ITS CORPORATION				REV	ECN	DATE	APV
THIS PRINT IS THE PROPERTY OF ITS CORP. IT SHALL NOT BE COPIED WITHOUT PERMISSION.				TITLE SCHEMATIC - DELAY EQUALIZER BD. (1227-1204)			
REV	ECN	DATE	APV	DWG. NO.			
1	7496	5/9/94	DWB	1227-3204			
2	7527	6/20/94	RE	6			
3	7571	8/9/94	DWB	C			
4	7808	5/31/95	DWB	1 OF 1

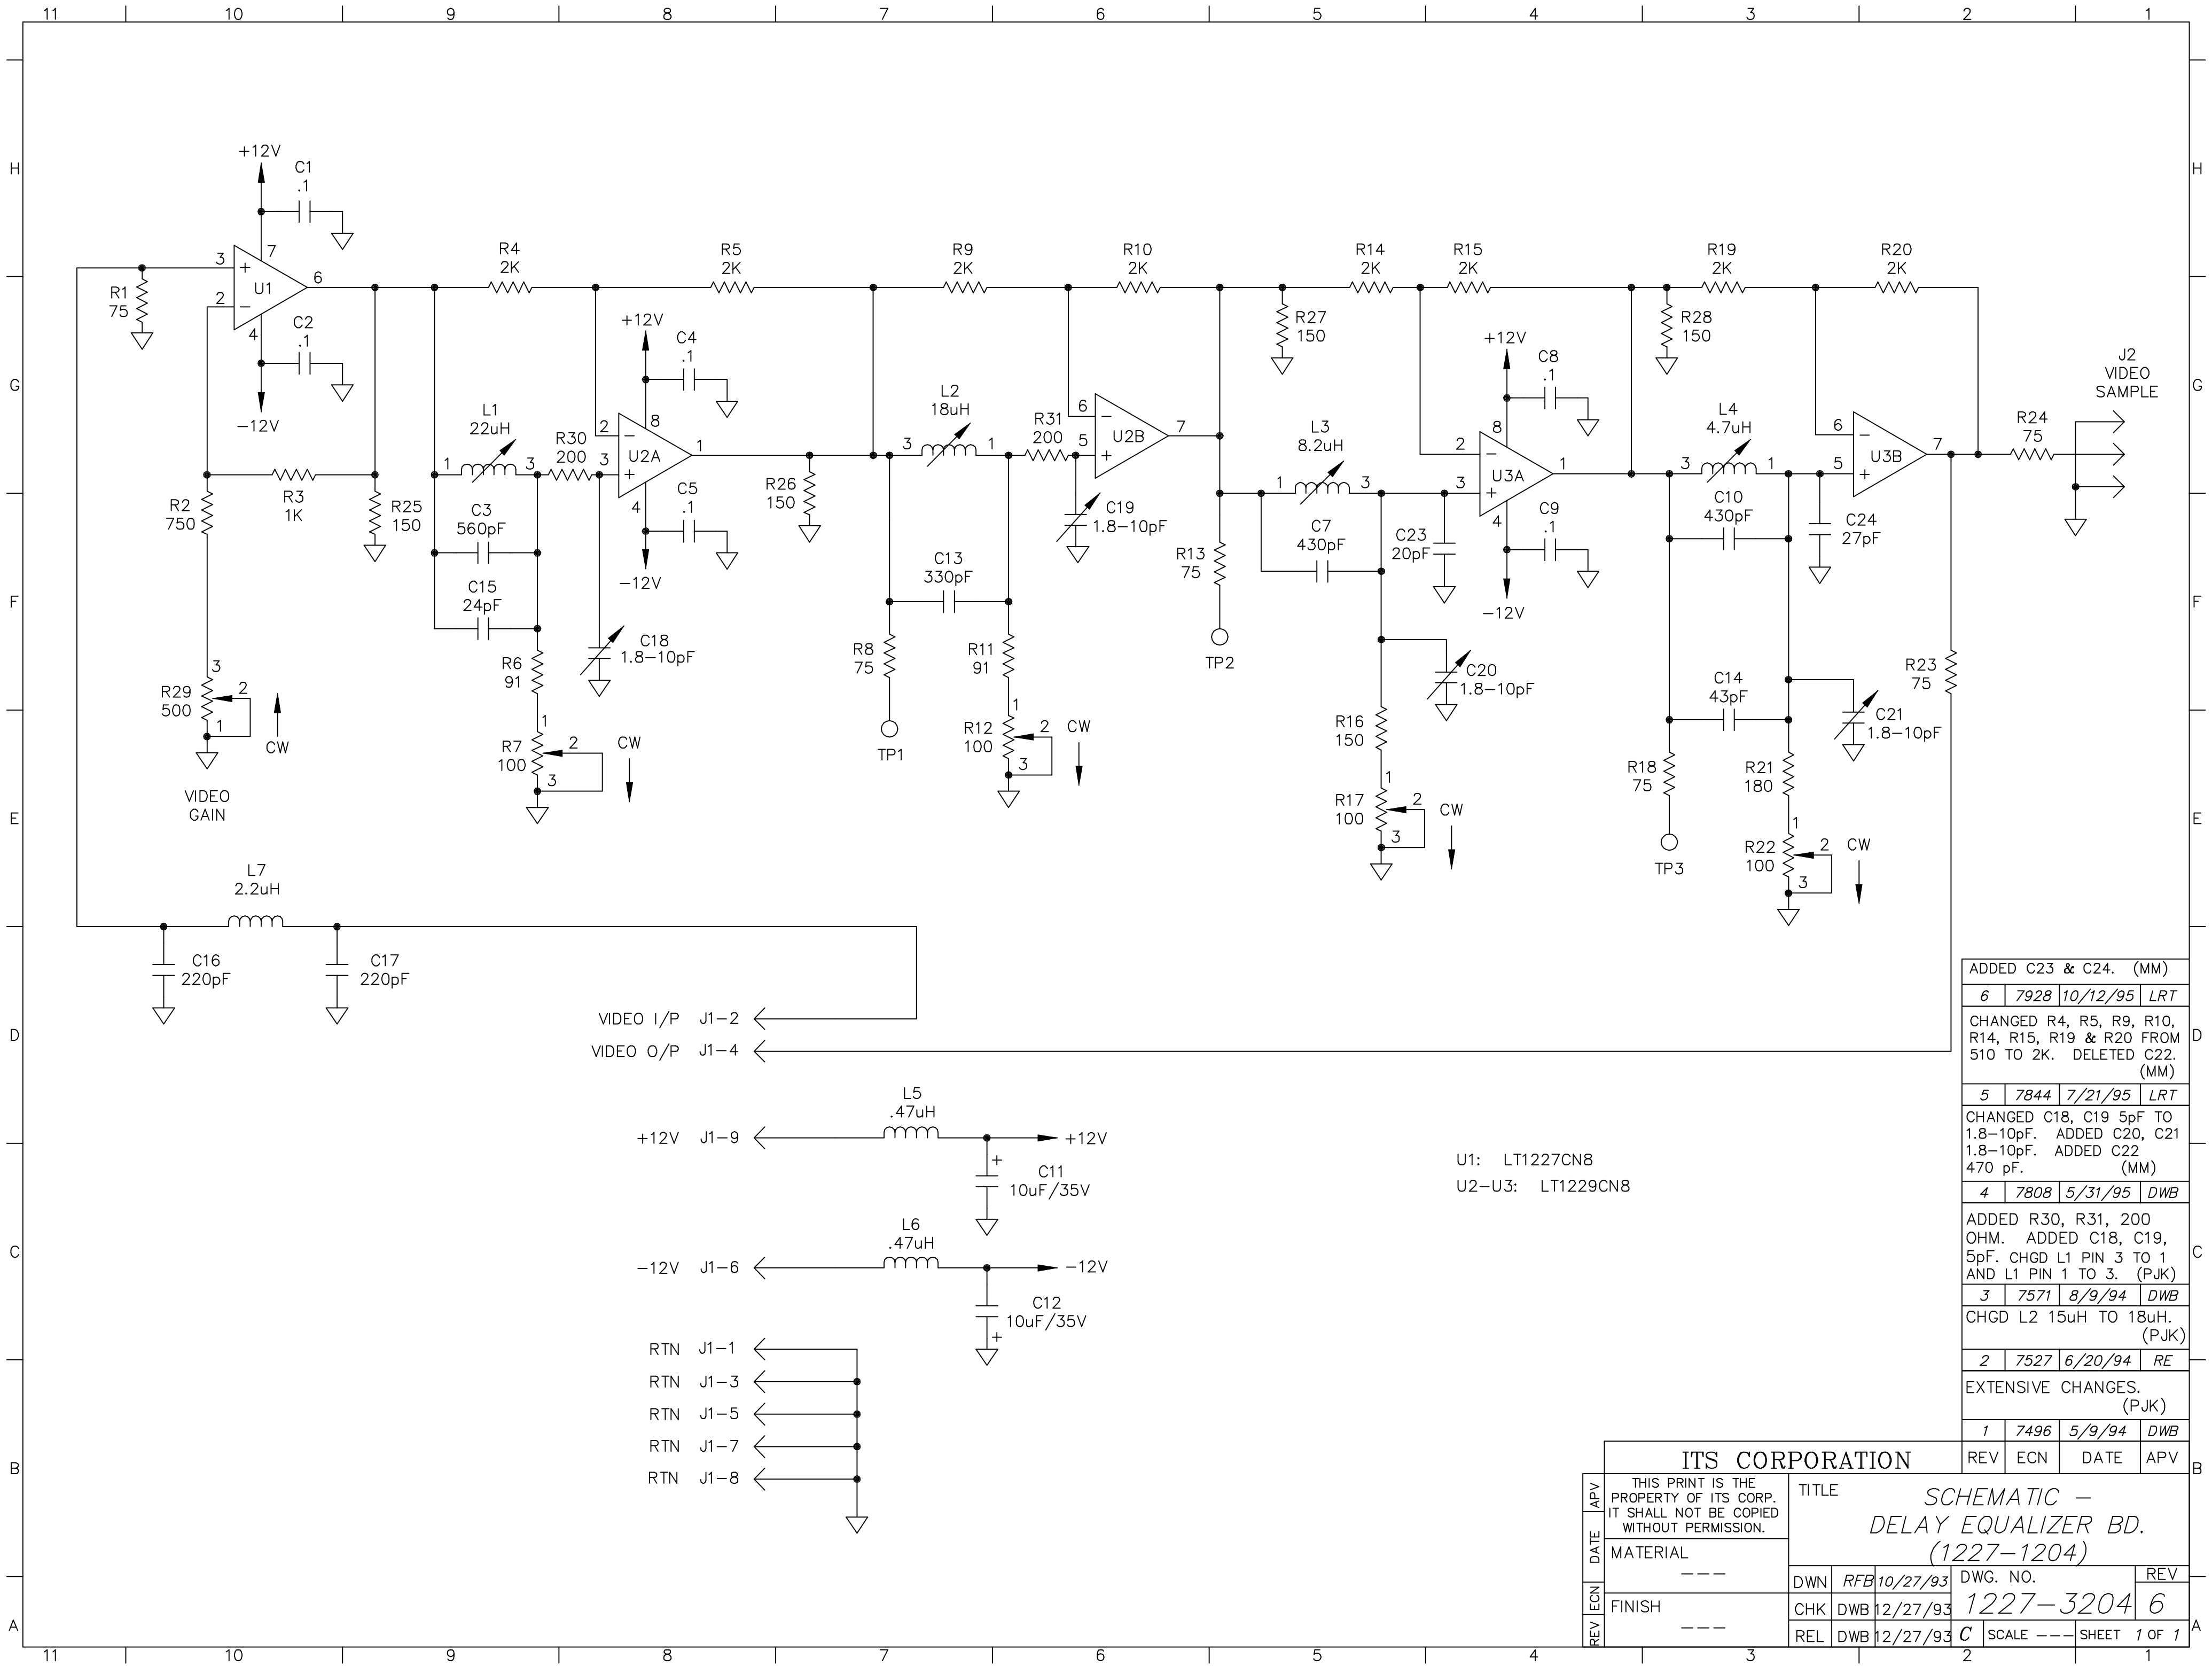
ADDED C23 & C24. (MM)			
6	7928	10/12/95	LRT
CHANGED R4, R5, R9, R10, R14, R15, R19 & R20 FROM 510 TO 2K. DELETED C22. (MM)			
5	7844	7/21/95	LRT
CHANGED C18, C19 5pF TO 1.8-10pF. ADDED C20, C21 1.8-10pF. ADDED C22 470 pF. (MM)			
4	7808	5/31/95	DWB
ADDED R30, R31, 200 OHM. ADDED C18, C19, 5pF. CHGD L1 PIN 3 TO 1 AND L1 PIN 1 TO 3. (PJK)			
3	7571	8/9/94	DWB
CHGD L2 15uH TO 18uH. (PJK)			
2	7527	6/20/94	RE
EXTENSIVE CHANGES. (PJK)			
1	7496	5/9/94	DWB
